Our Reference: 21616/A5/EIA Letter
10th February 2023

RE: LANCASHIRE CENTRAL (LCC/2022/0044) – LANDSCAPE AND VIEWS LETTER OF COMPLIANCE

Application No: LCC/2022/0044	Consultation Ref No: N/A
Proposed Development/Plan/Project: Application for Outline Planning Permission (with all matters reserved save for access from the public highway and strategic green infrastructure/landscaping) for a mixed-use development including the provision of Employment use (Use Classes B2/B8/E(g)); retail (use Class E(a)); food, drink and drive-through restaurant use (Use Class E(b)/Sui Generis Drive-Through); hotel use (Use Class C1); health, fitness and leisure use (Use Classes E(d)/F(e)/F2(b)); creche/nursery (Class E(f)); car showrooms (Use Class Sui Generis Car Showroom); Residential use (C3) the provision of associated car parking, access, public open space, landscaping and drainage.	
Location: Cuerden Strategic Site, East of Stanifield Lane, North of Clayton Farm, West of Wigan Road, Lostock Hall	
District: South Ribble	
Type of Consultation: Planning application	Date: 22/11/2022

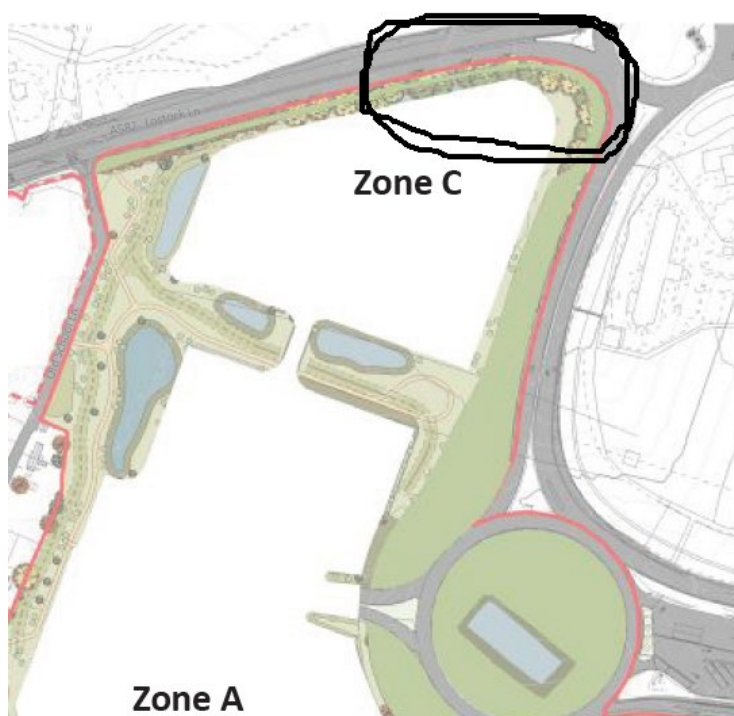
- **Indicative Access Diagram**
3 ponds are clearly visible within the area outlined in black.
(Please note, the ponds need to be located away from the root protection areas of existing boundary vegetation)

The above pond proposals contradict those on some of the other applicant's plans, e.g.

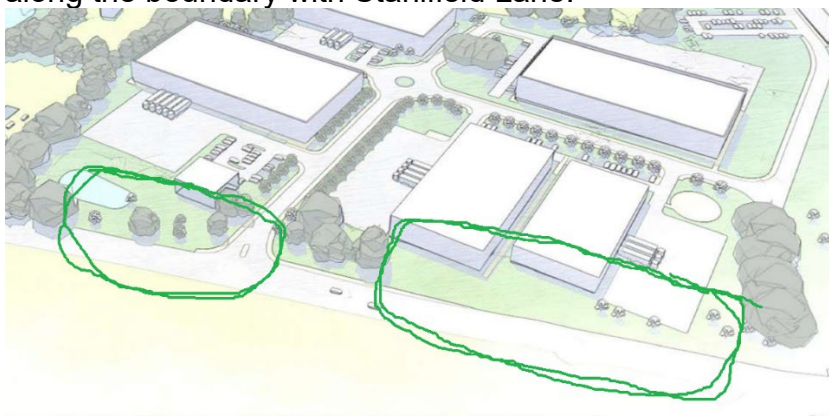
- "Substantial landscaping" (ref **b. Block Principles (access, frontages, car parking, refuse/ servicing)**) is proposed to separate the two character areas/zones A and C but no specific, detailed parameters have been provided for it. The proposed landscape buffer along the boundary with Lostock Lane is not wide enough for the amount of mitigation planting required unless of course the applicant intends to allow views of the proposed buildings from this road. There is no indication in the text as to which option the applicant prefers.

Parameters Plan 3 - Strategic Landscape

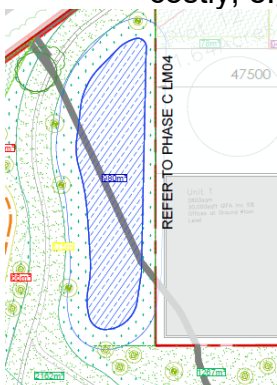
- This plan is of little use as it has no key for the proposed strategic landscaping. *As a minimum* this parameters plan should provide clear detailed information on the following elements of the 'strategic' landscape where they are proposed:
(*Please note, this list is not meant to be all inclusive*)

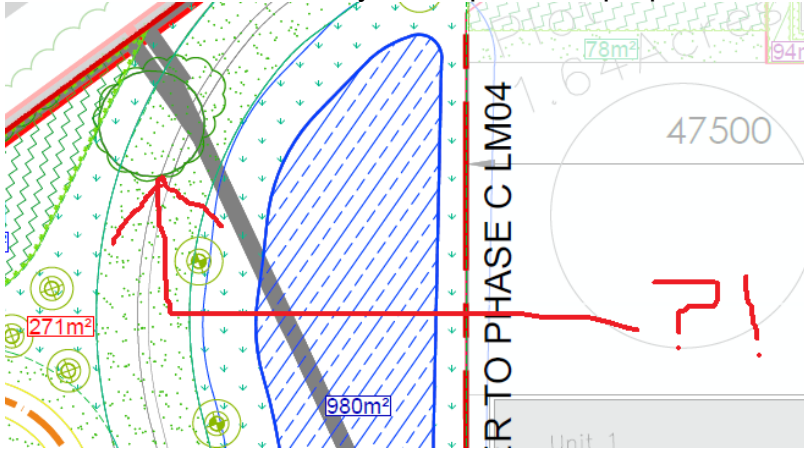
- As can be seen in the examples below (*note, not an exhaustive list*), excavation and other works are proposed within the root protection areas of existing trees and hedgerows intended for retention.

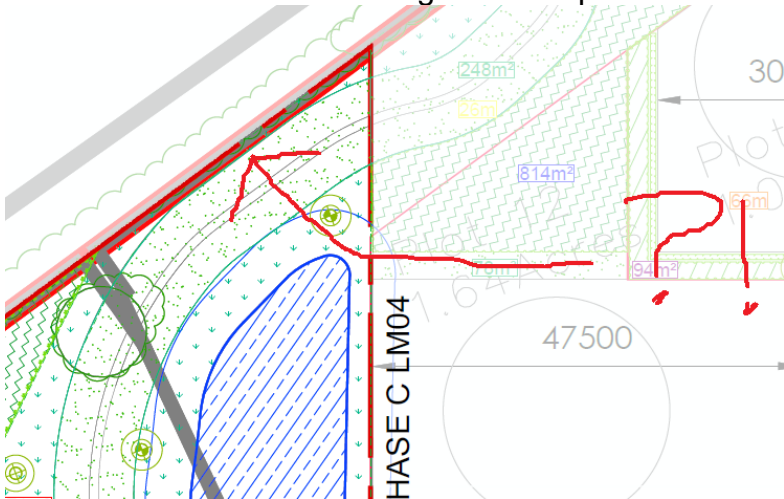
- Tree directly in the path of a proposed SUD (swale?):

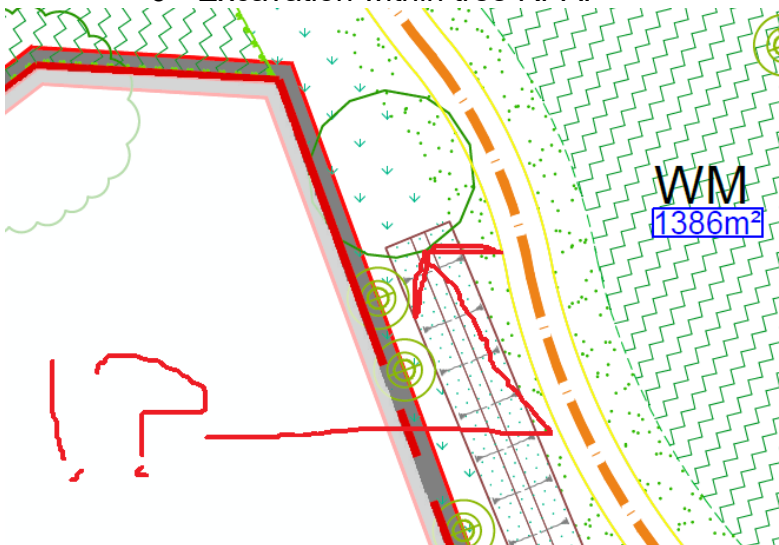
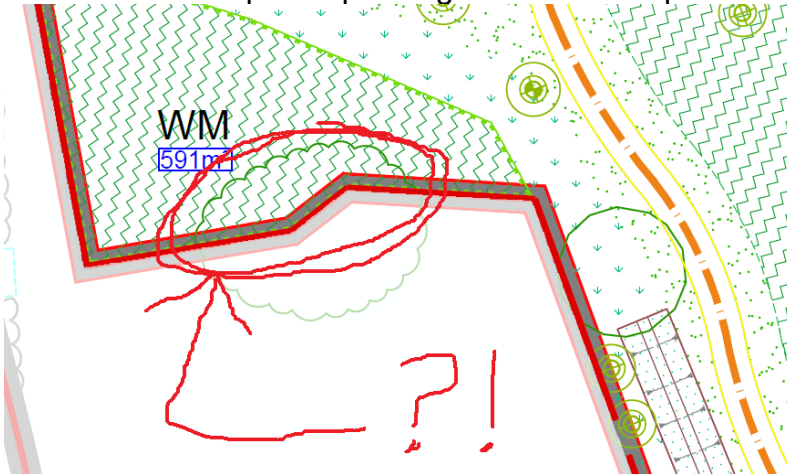
- SUD within hedgerow root protection area (RPA):

- Excavation within tree RPA:

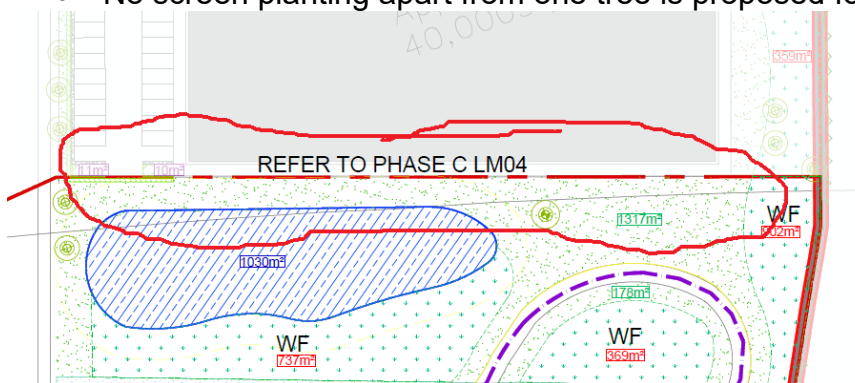
- Proposed planting within RPA of plants within private land:

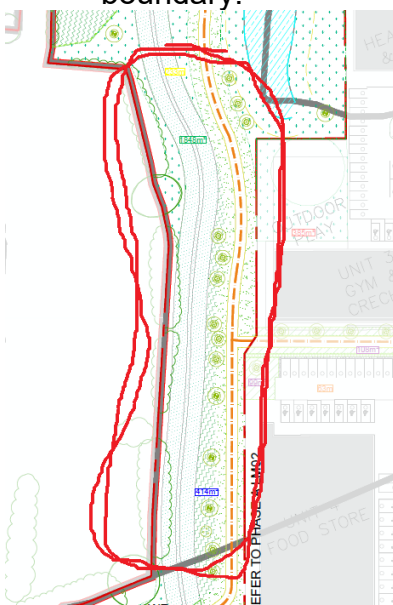
- Existing residences should have been shown on the drawing so that those directly affected by the scheme proposals could see what mitigation measures are proposed for their property.
- No screen planting apart from one tree is proposed for the rear of Unit 4:

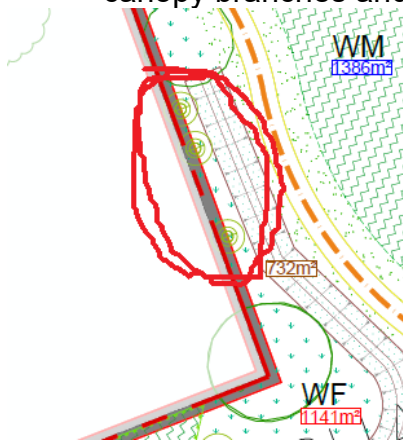
- The proposed location of the SUD (excavated within the RPA's of existing planting) leaves little room for screen planting along part of the western boundary:

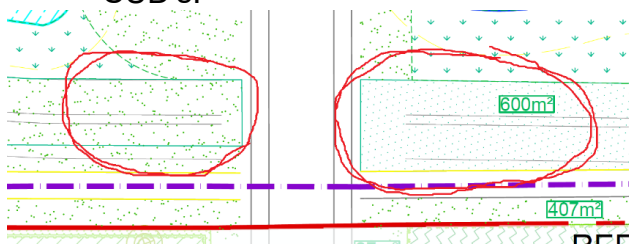
- As the trees in the highlighted area below would be planted directly on the site boundary, their canopies at maturity would overhang adjacent land. In addition, as the trees matured any boundary fencing could be damaged by canopy branches and/or expansion of the root plate.

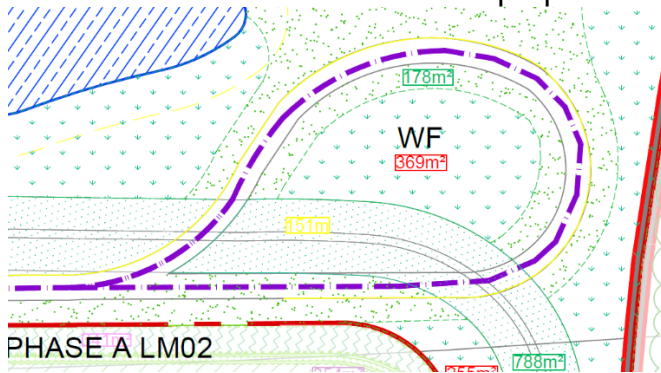
- As with the **Parameters Plan 3 - Strategic Landscape**, the Phase A drawing shows various works proposed within tree and hedge RPA's.
- Vegetation intended for removal and root protection areas of trees/shrubs/hedges to be retained **must** be shown on the drawing. Without this vital information, the scheme's full impacts on existing vegetation and the requirements for mitigation/compensation (including biodiversity net gain calculations) cannot be determined.
- The area within the red outline below has no hatching. Why?

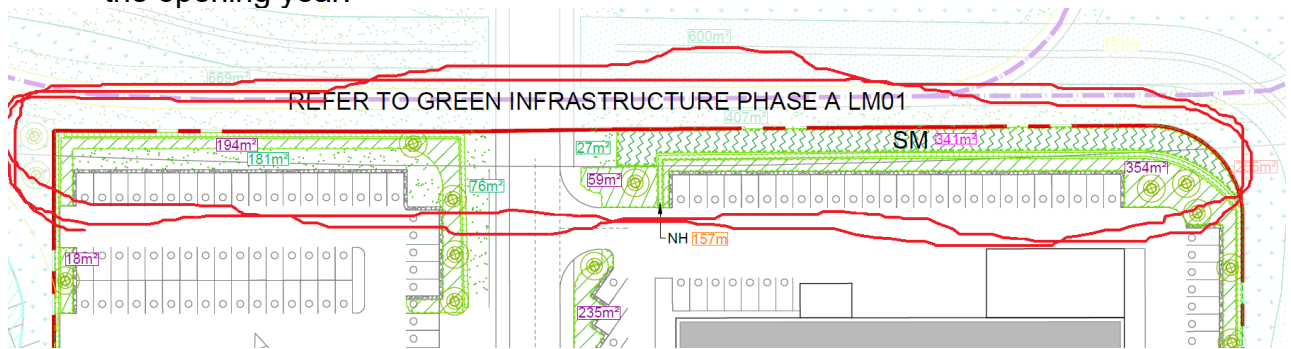
- It is difficult to see what the purpose of this short circular length of path is for:

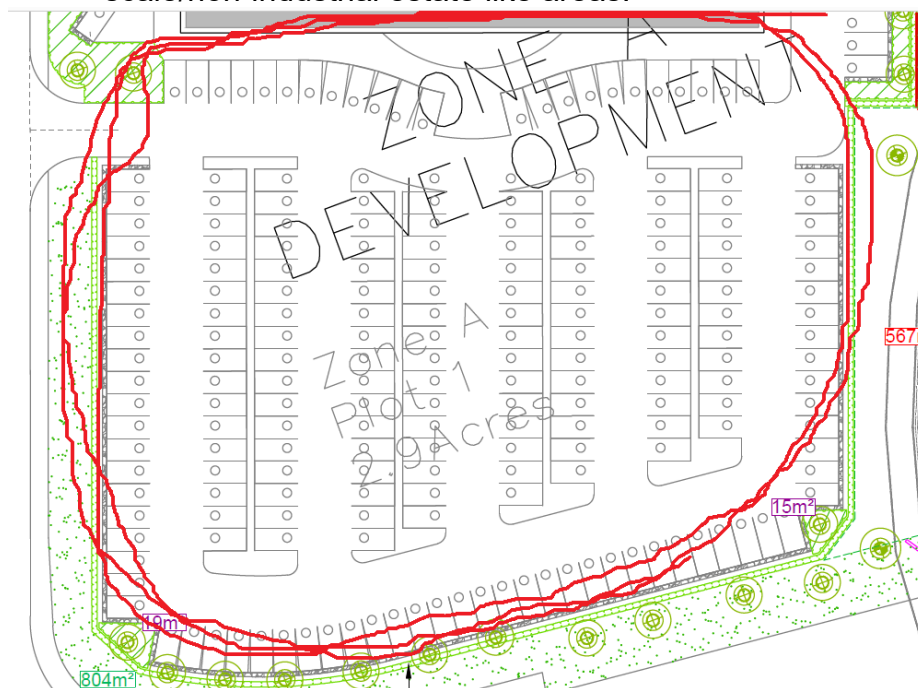
- Heavy standard and extra heavy standard trees are required along the boundaries within the red outline to provide more effective minimisation of the adjacent car park's impacts and nearby buildings on views from the path in the opening year:

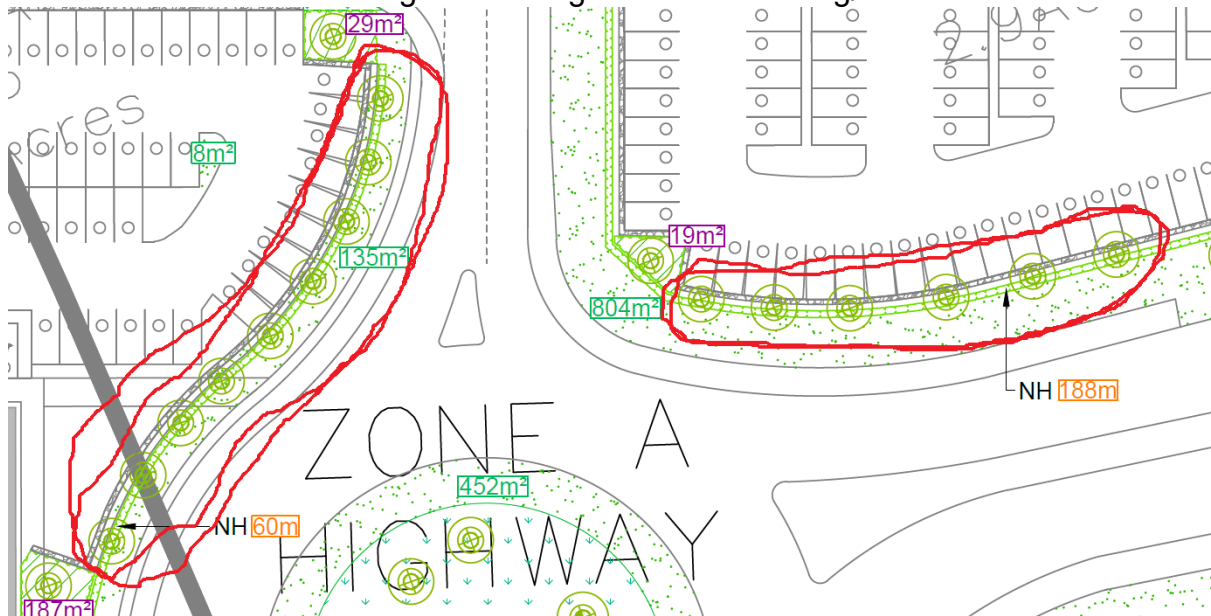
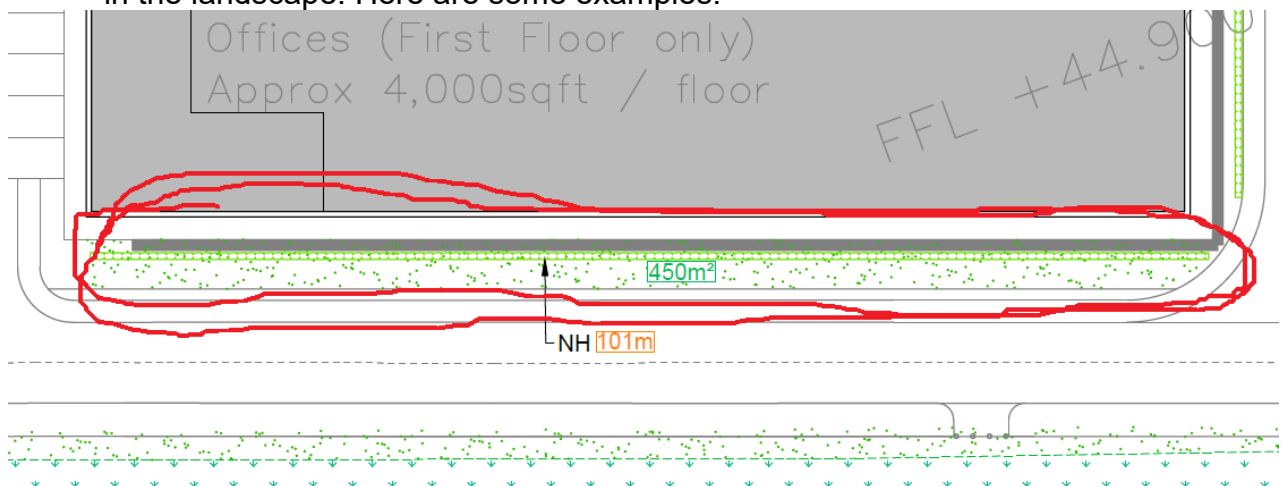
- To ensure that trees do not cause future problems arising from being planted too close to structures, it is essential that the requirements of BS5837 are used to guide the choice of locations for proposed tree planting. As can be seen from the screenshots below, the proposed tree locations are far too close to car parks. As the trees matured this could lead to problems arising from branch overhang and damage to road surfacing/kerbs:

(Please note: the above are not the only locations where here trees are proposed too close to structures)

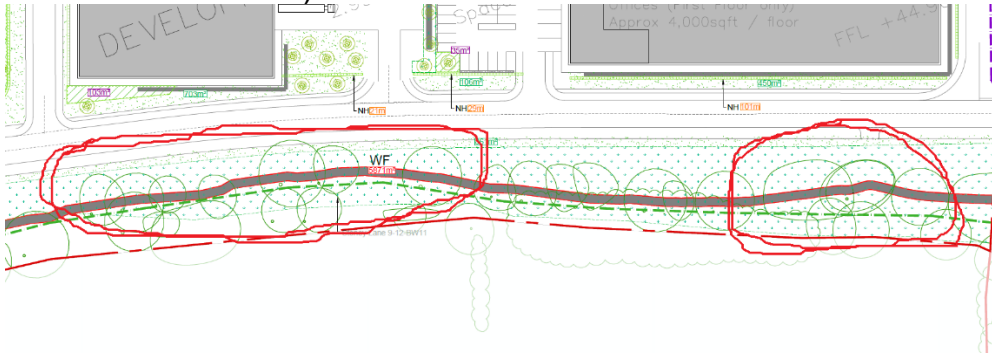
- Generally, the proposed mitigation planting around the larger structures is inadequate. In many cases the proposed ornamental hedges would be dwarfed by the large industrial structures exacerbating their discordant scale in the landscape. Here are some examples:

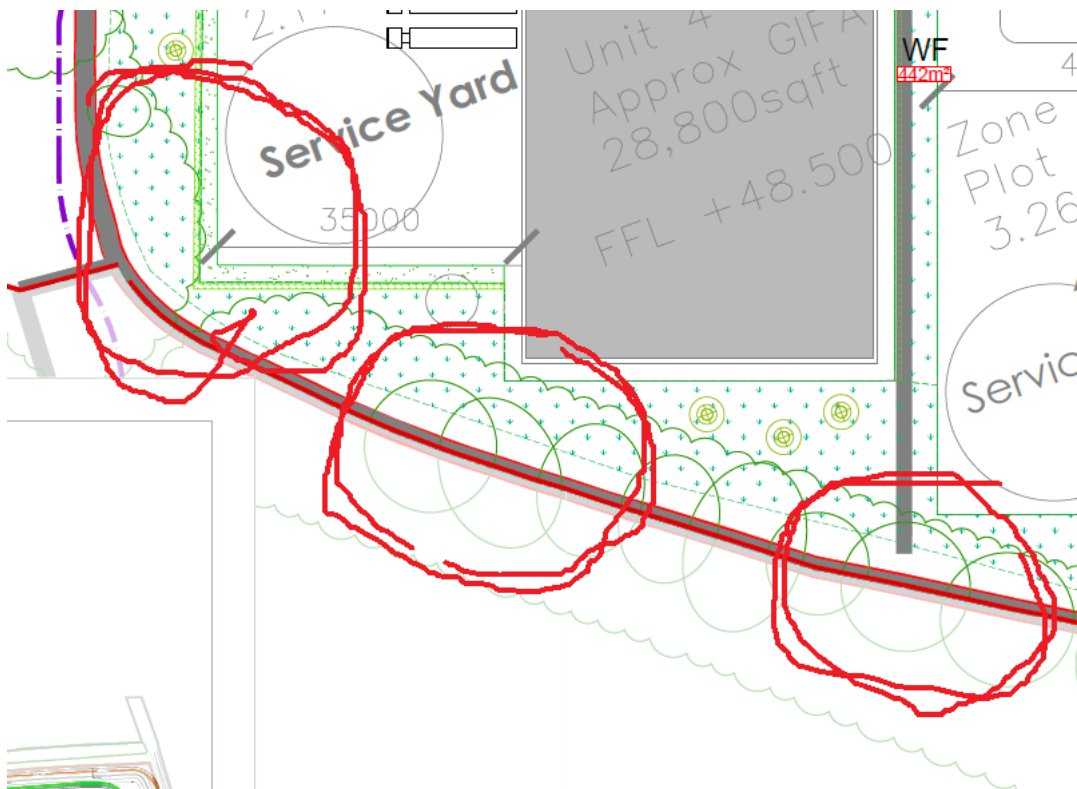
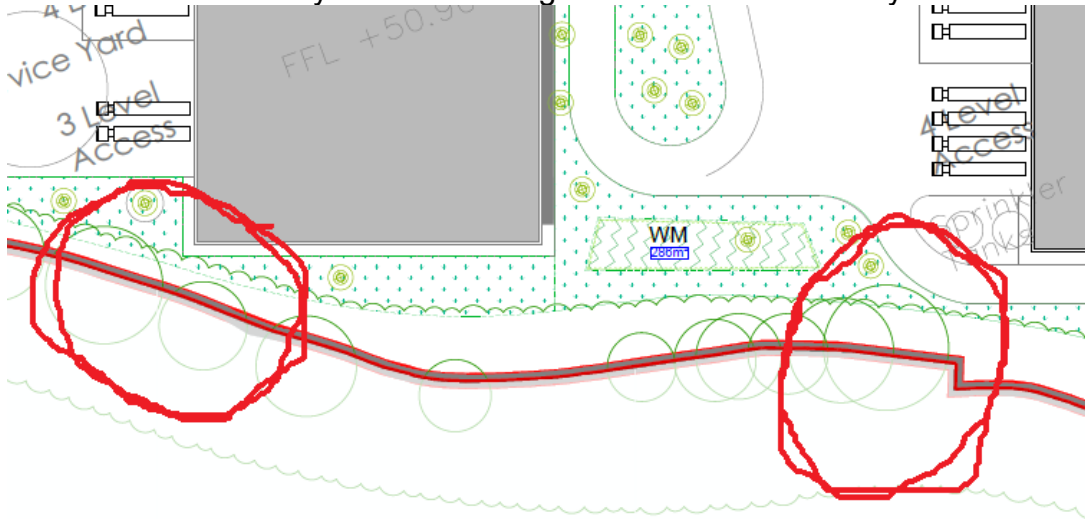
- Preserving the row of trees along the southern boundary and integrating them into the proposals should be one of the applicant's key landscape priorities as

these trees could provide substantial mitigation of the new building's visual effects and maintain some habitat connectivity through the site. In developing the layout of the site, the applicant appears not to have considered the impacts of the building/road/service area construction would have on these southern boundary trees. These screenshots show – within the areas bounded by a red line – a range of works proposed within existing tree RPA's that would likely affect their long-term health and viability:

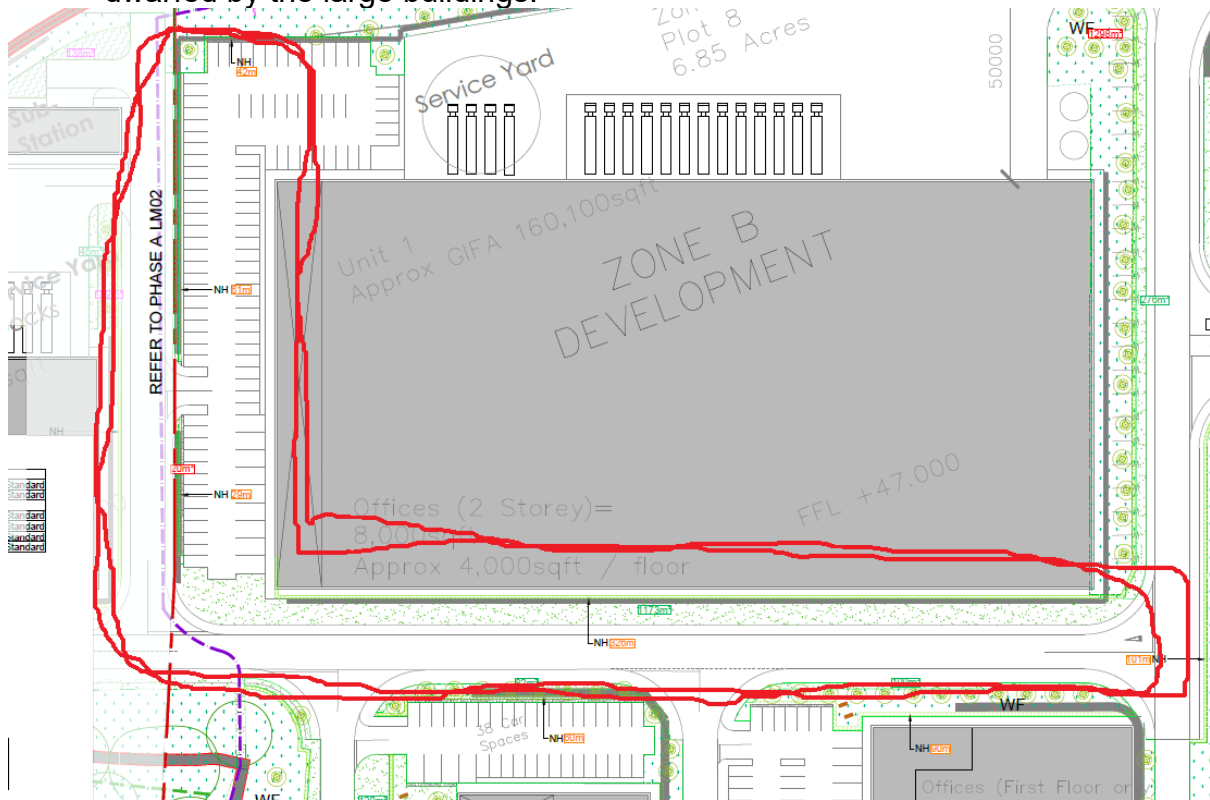
- As discussed for Phase/Zone A, the scale of some of the proposed industrial buildings and the density of the development greatly limit opportunities for designing a landscape structure suitable for creating an attractive public realm that also benefits biodiversity to the same extent as that proposed for

Phase/Zone A. The area that Unit's 1, 3 and 4 would be located within for example have very limited mitigation planting largely confined to areas left over after space has been allocated for buildings, roads, car parks, etc. The outcome – narrow grassed highway verges, no tree planting and ornamental hedgerows as shown below – would have little mitigating effect and be dwarfed by the large buildings:

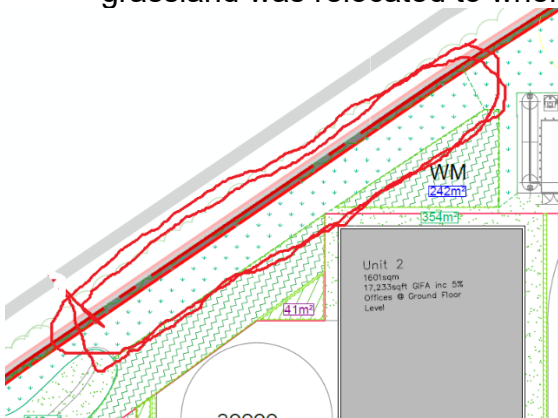
- As with the **Parameters Plan 3 - Strategic Landscape**, the Phase C drawing shows various works proposed within tree and hedge RPA's.
- Vegetation intended for removal and root protection areas of trees/shrubs/hedges to be retained **must** be shown on the drawing. Without this vital information, the scheme's full impacts on existing vegetation and the requirements for mitigation/compensation (including biodiversity net gain calculations) cannot be determined.
- Two of the proposed ponds in the area bounded by the red line in the screenshot below would take up much needed space for mitigation planting along the northern boundary.:

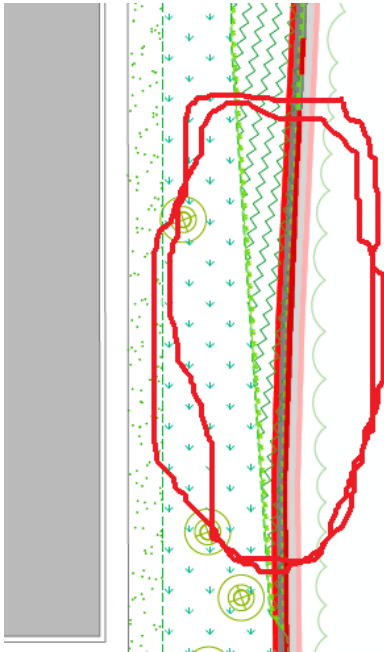
- Unlike most of the proposed planting areas within the scheme, the two important areas of screen planting highlighted by the red outlines below would have no heavy standard or extra heavy standard trees. These trees are crucial for providing immediate impact in the opening year:
